310-314 BUSHMAN DRIVE, FLAGSTONE

OPERATIONAL WORKS APPLICATION - SIGNAGE
INFORMATION REQUEST RESPONSE

AUGUST 2026 | 1133-013 | OWADV/15/2026

**RE: RESPONSE TO INFORMATION REQUEST
DEVELOPMENT PERMIT FOR OPERATIONAL WORKS ADVERTISING DEVICE – OFF-PREMISES SIGN
(X2)**

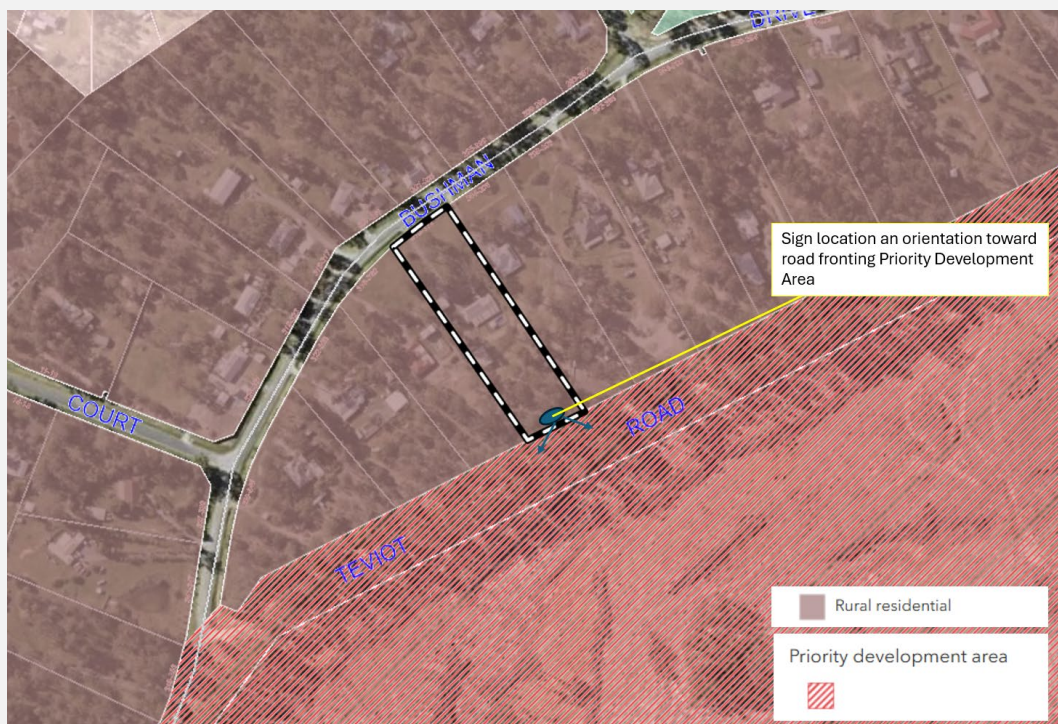
Provide further details regarding how the proposed advertising device will visually integrate with the built form and streetscape character of the Rural residential zone as per PO1 of the Advertising device code.

While the subject site has frontage to Bushman Drive, which forms part of the established Rural Residential character area, the proposed sign is not oriented toward, nor visible in any way from the Bushman Drive frontage. The sign is instead sited and orientated toward the rear of the property, addressing the arterial road that provides direct access into the Greater Flagstone Priority Development Area (PDA).

This distinction is critical to the PO1 assessment. The rural residential built form and streetscape character that PO1 seeks to protect is expressed along the Bushman Drive frontage, through low-density rural residential lots, rural fencing, landscaped setbacks and the general absence of urban signage. The sign will have no visual presence within, or relationship to this streetscape. A person travelling along Bushman Drive, or occupying a rural residential lot with frontage to it, will not perceive the sign as part of that streetscape.

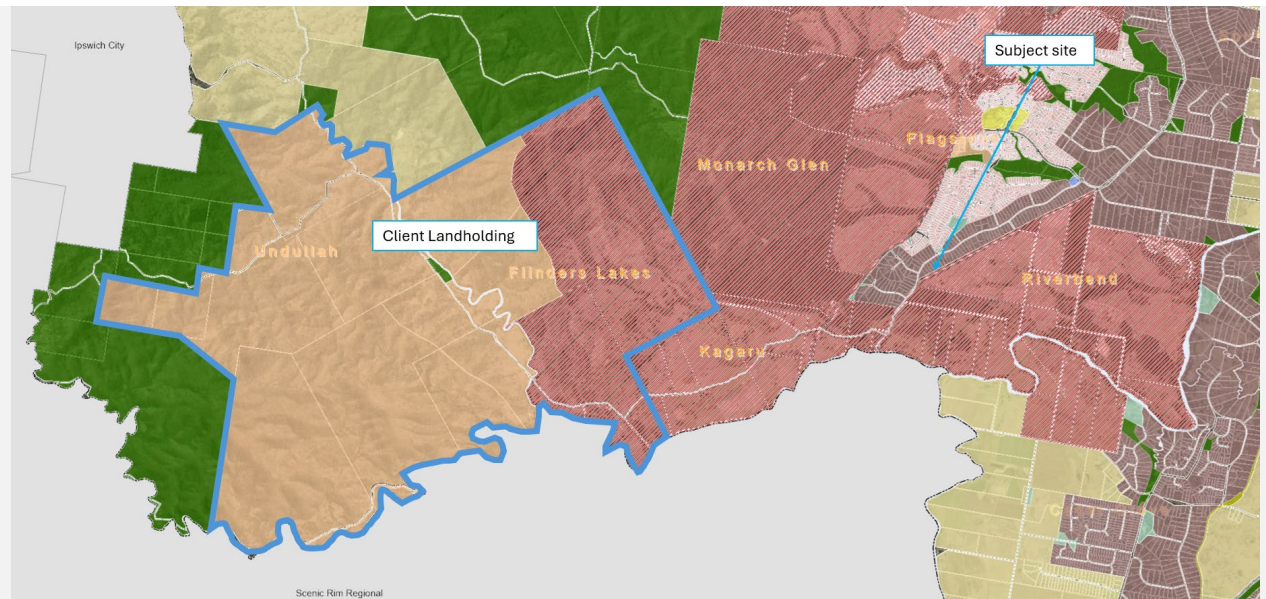
Provide further justification why this property is the proposed location for the sign.

There are additional properties along Teviot Road which are further from the approved signage at 330-346 Bushman Drive which could be investigated as alternate proposal locations, unless sufficient further justification is provided and accepted by Council officers. The site is also located in the Regional Landscape and Rural Production Area under ShapingSEQ 2023, therefore urban development intensification is not expected in this area.

The proposed sign location has been selected on the basis of its direct functional relationship to the arterial road network serving the client's landholding, rather than on the basis of proximity to, or separation from, the approved sign at 330-346 Bushman Drive alone. As shown within the below plan, the sign is proposed on the recently constructed section of Teviot Road, which links directly to Flinders Lakes Drive, the arterial route providing access into the client's landholding to the west, a masterplanned community of approximately 4,000ha comprising approximately 22,000 dwellings. The sign is intended to orient and direct prospective purchasers travelling along both directions of this arterial corridor toward Flinders Lakes, at the location where motorists are both approaching and leaving the Masterplanned area.

It is reiterated that the proposed sign is read completely separately from the approved sign at the junction of Bushman Drive and Teviot Road, given the change in road tangent point and the clear visual separation between the two signs, as demonstrated by the site inspection evidence provided in response to PO2 above. On this basis, Council's request to consider alternate locations further along Teviot Road to increase separation is not considered relevant, as the two signs do not compete or interact visually irrespective of the distance between them.

Regional Landscape and Rural Production Area (ShapingSEQ 2023)

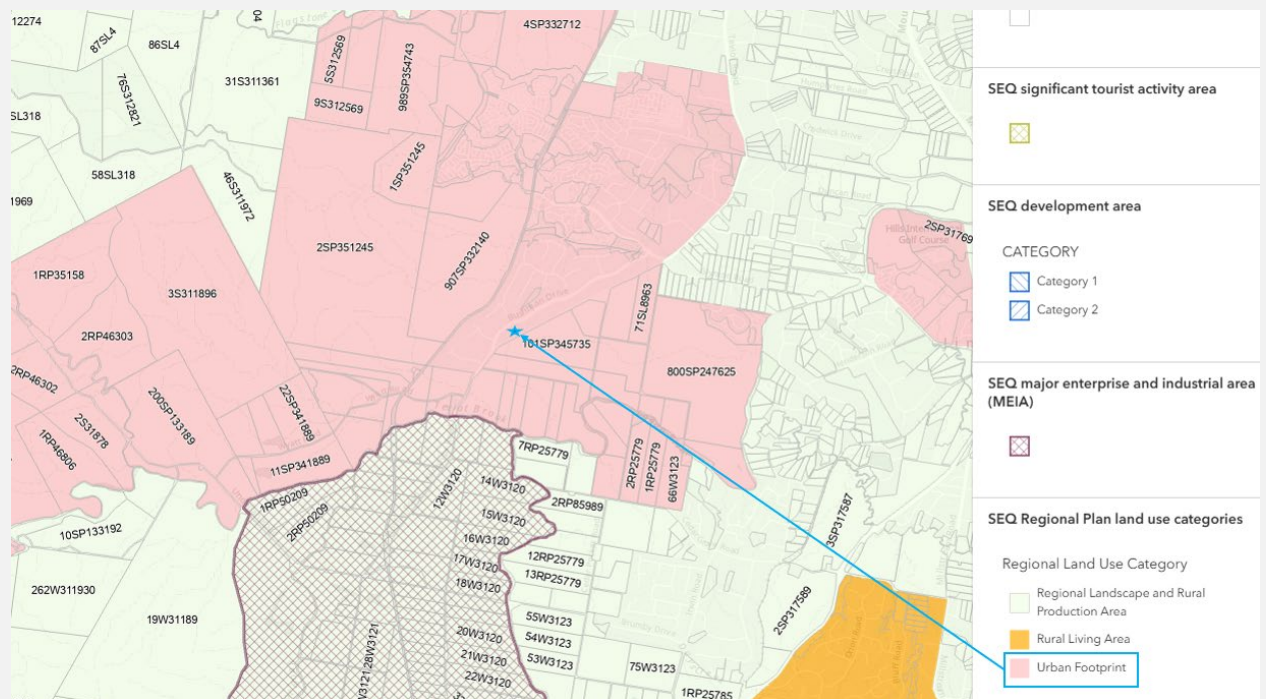
Council further advice comment:

The Officer's comments state that the site is located within the Regional Landscape and Rural Production Area under ShapingSEQ 2023. This is factually incorrect, as shown in the attached ShapingSEQ 2023 mapping extract, the subject site is located within the **Urban Footprint**, consistent with its proximity to and functional relationship with the Greater Flagstone PDA, and it is respectfully requested that Council's assessment be updated accordingly. Notwithstanding this correction, it is in any event noted that the regional planning designation applying to the subject land does not, in itself, preclude a temporary directional sign of this nature, which is not a development outcome inconsistent with the Regional Landscape and Rural Production Area intent.
